Northwestern Water and Sewer District  
2024 Portage Water Main Replacement  
WL-306E

**ADDENDUM 1**

8/8/24

SR-1.1-2

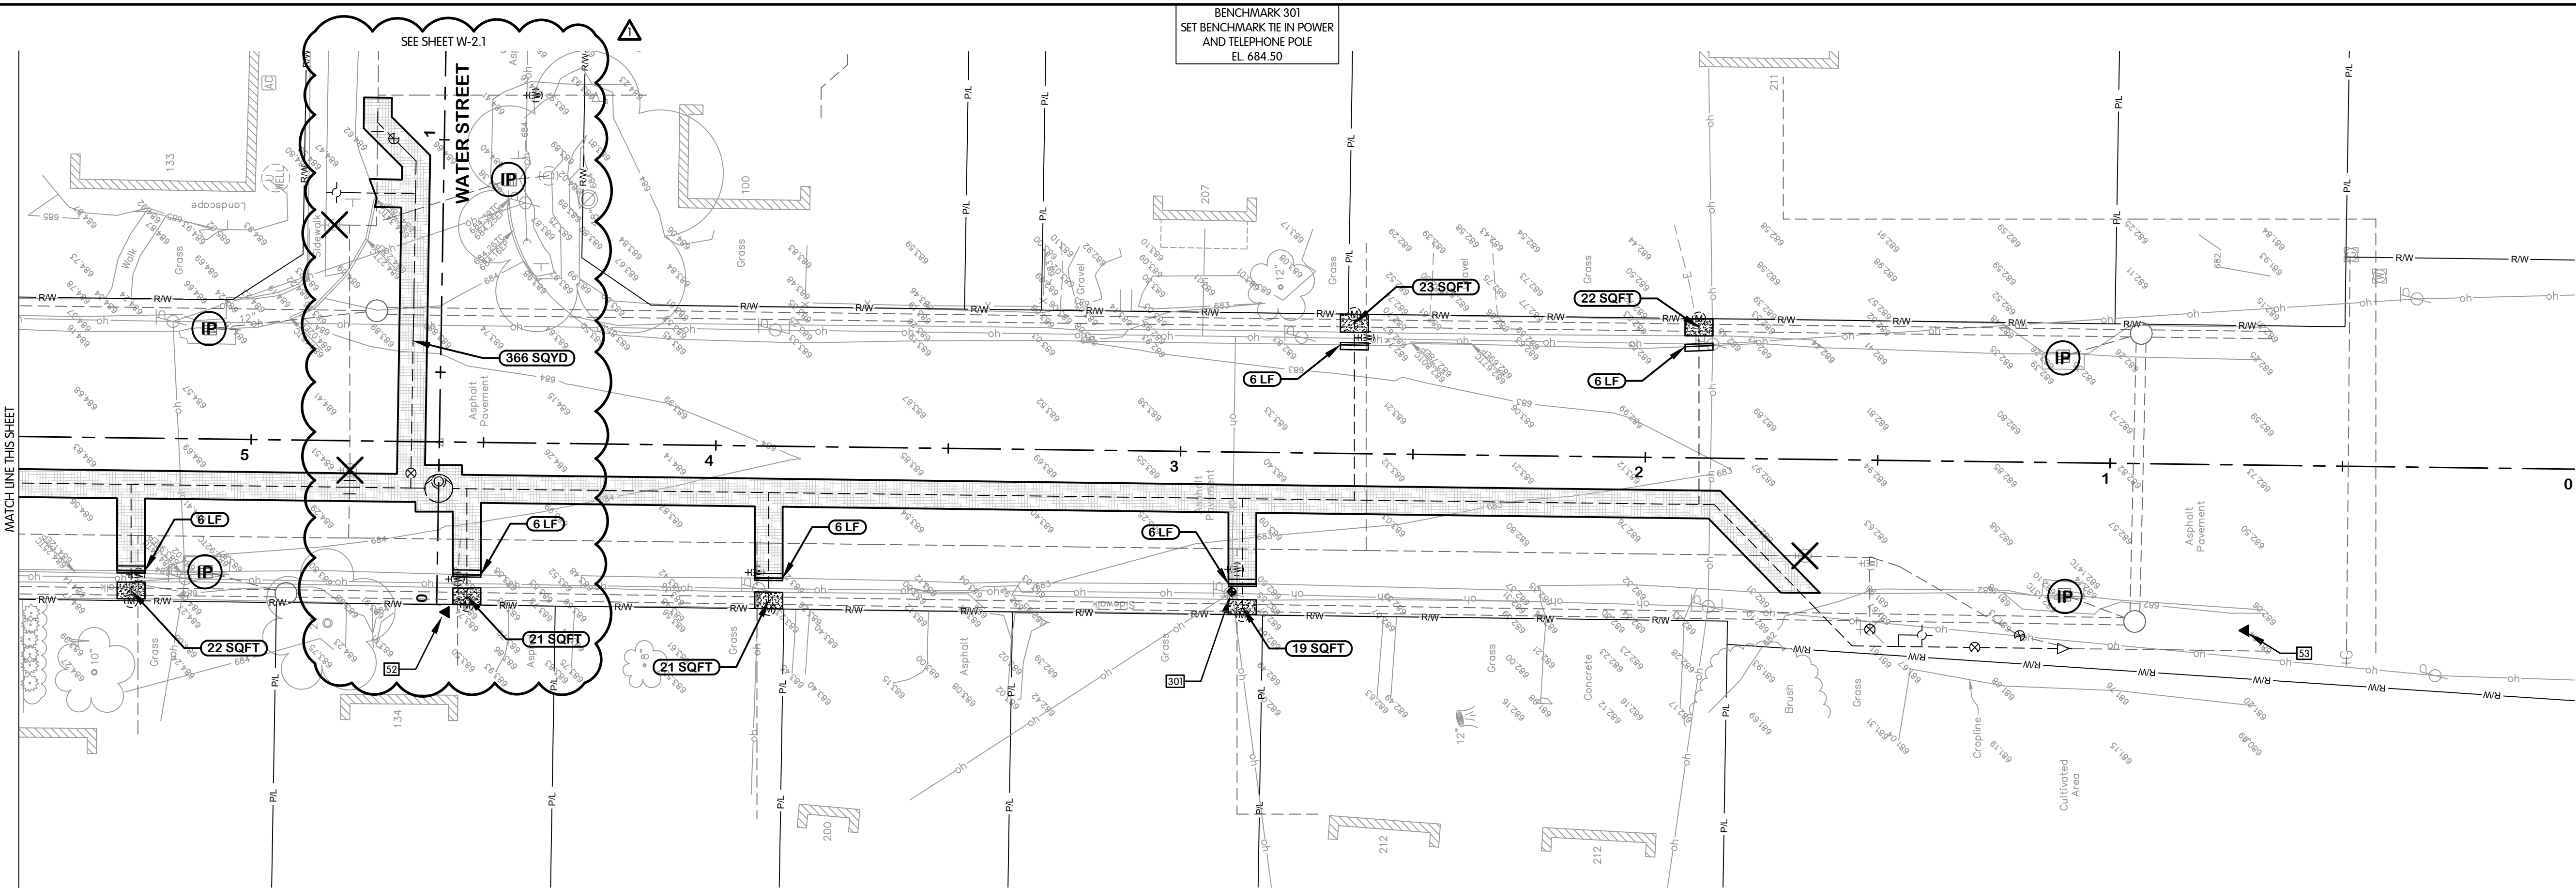
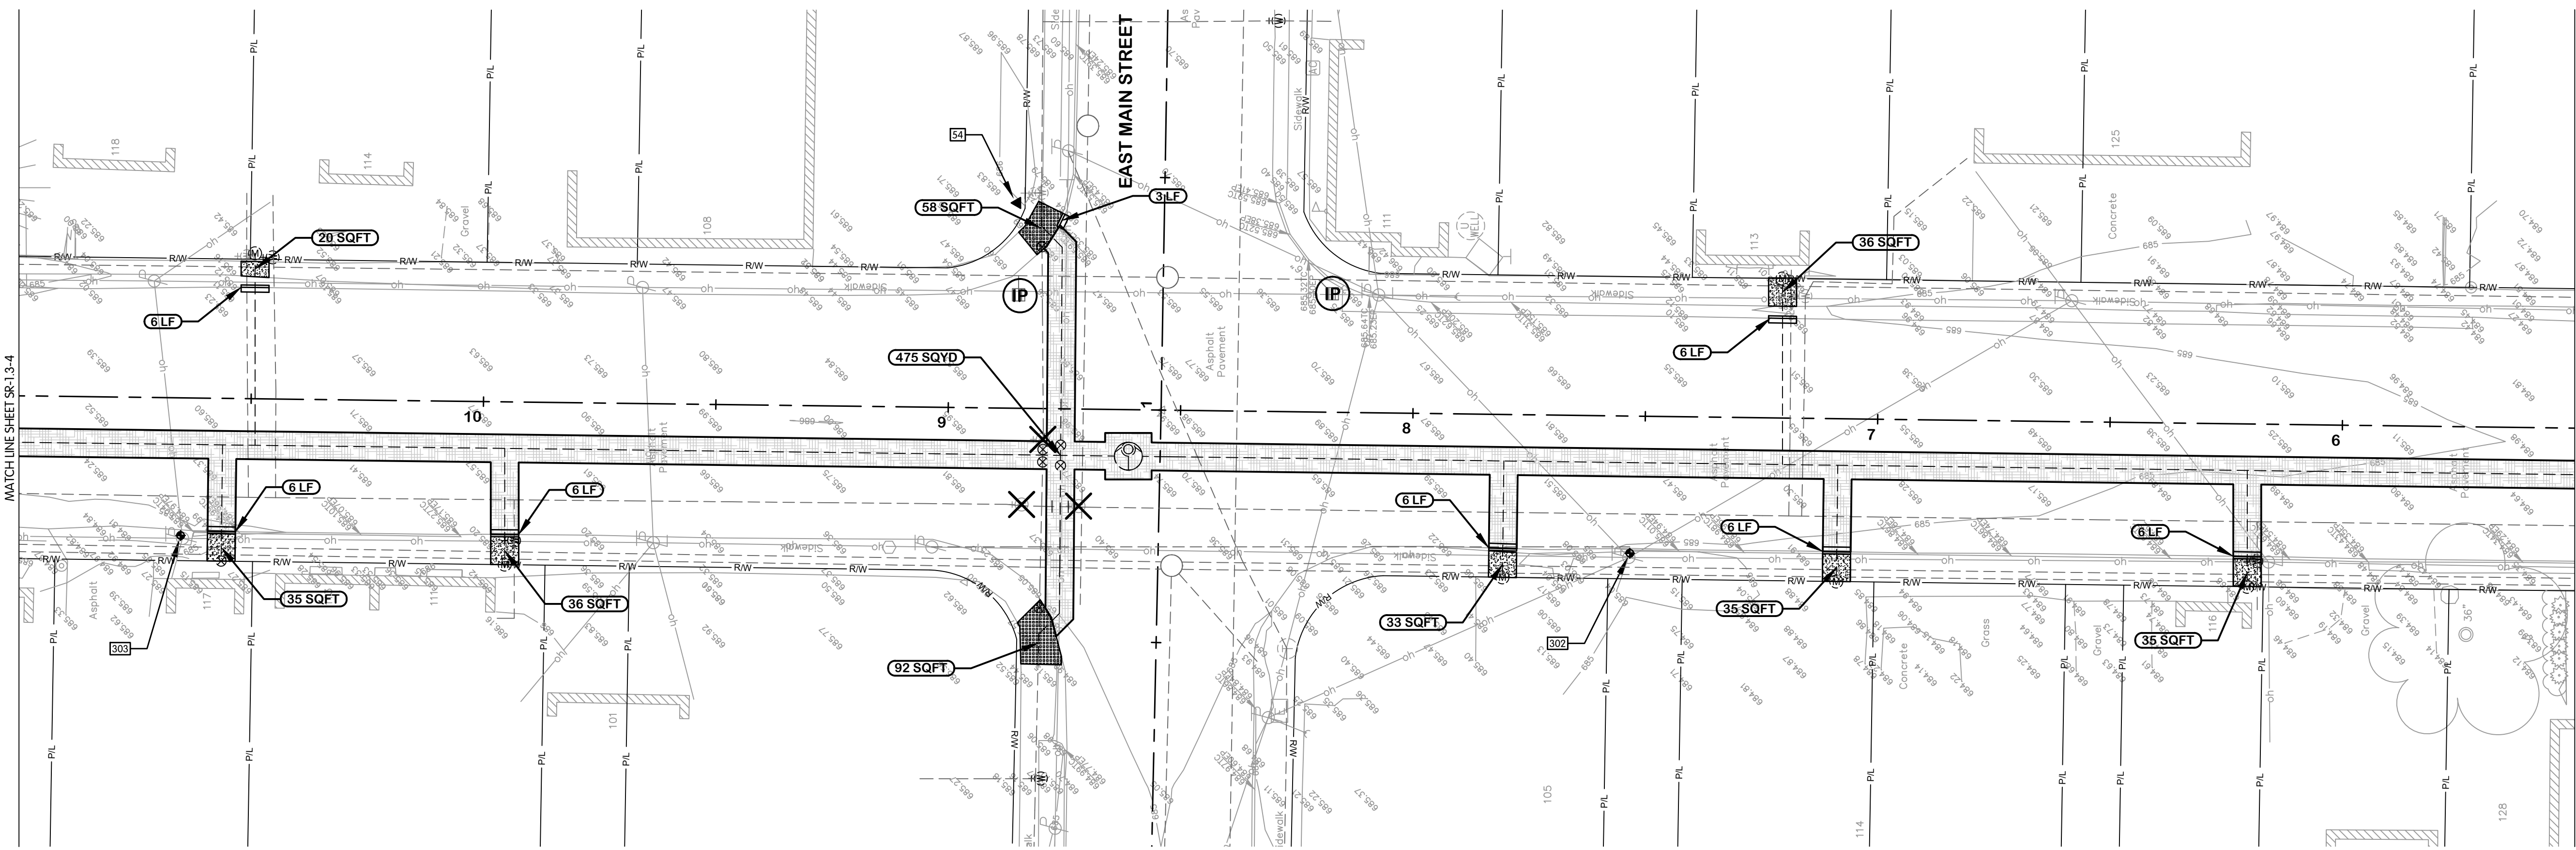
Replace Sheet SR-1.1-2 with the attached sheet that shows the updated surface repair for the connection at Water Street.

**PAVEMENT TRENCH REPAIR TYPICAL SECTION  
(RESIDENTIAL PAVEMENT) - CLOSE STREET**  
NTS

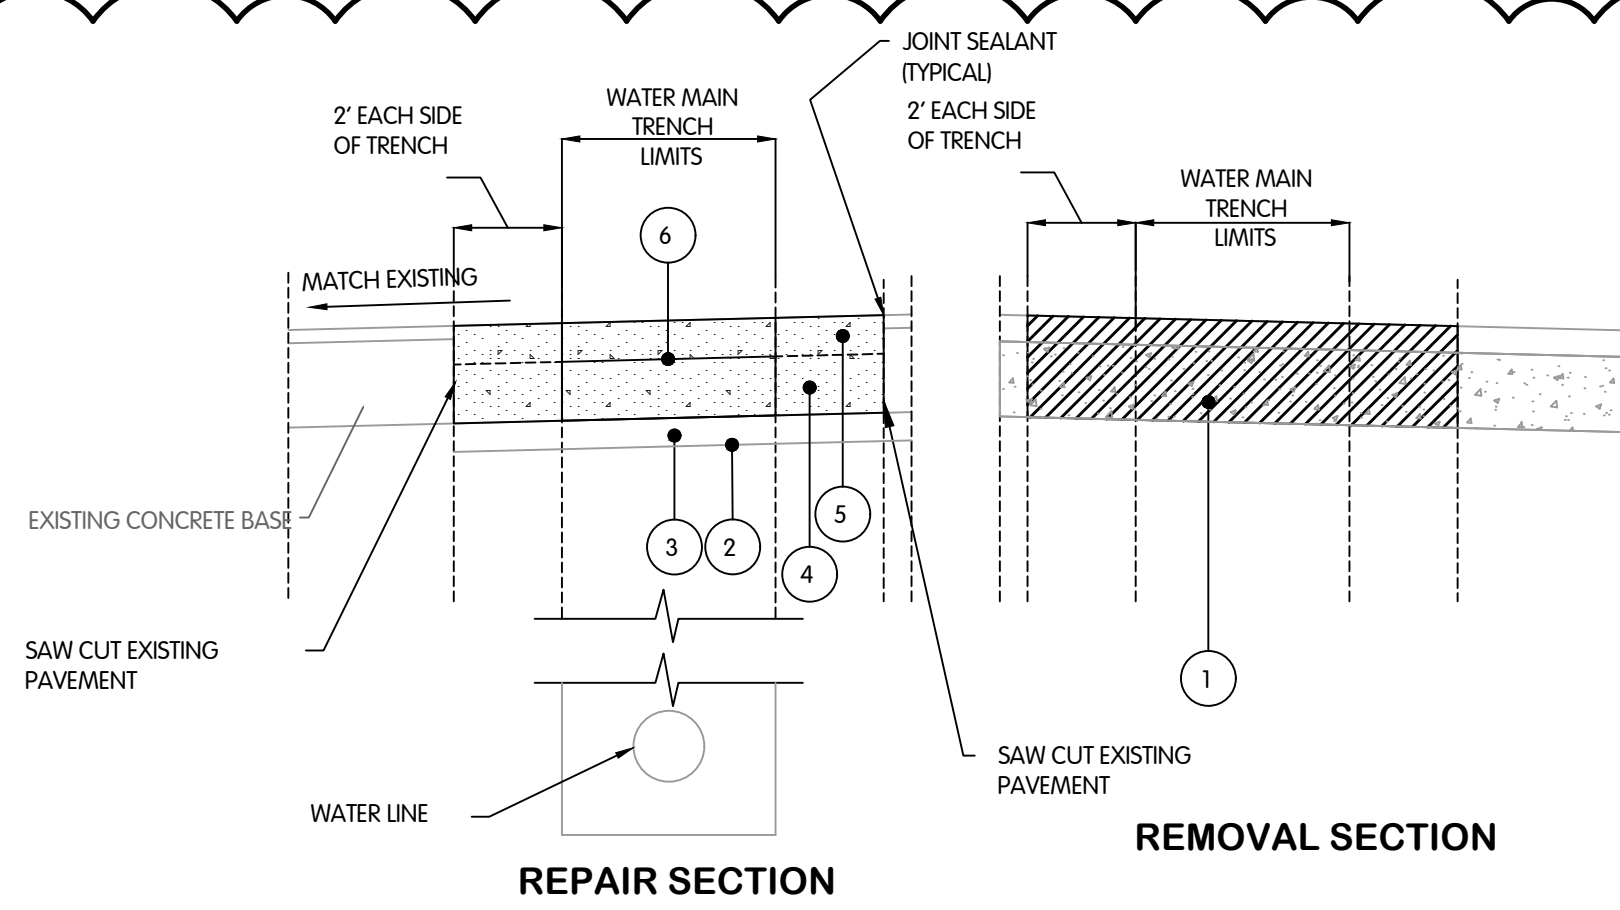
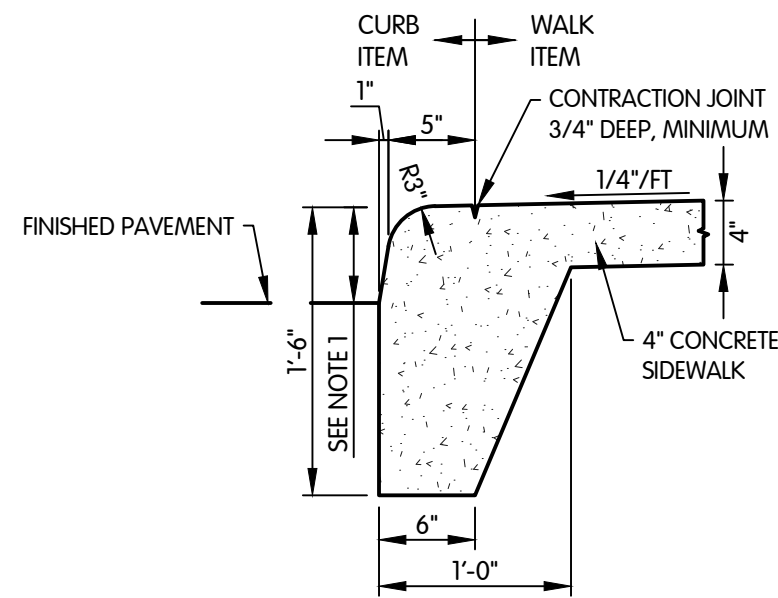
Replace Sheet SR-0.1 with the attached sheet that shows the updated trench repair details.
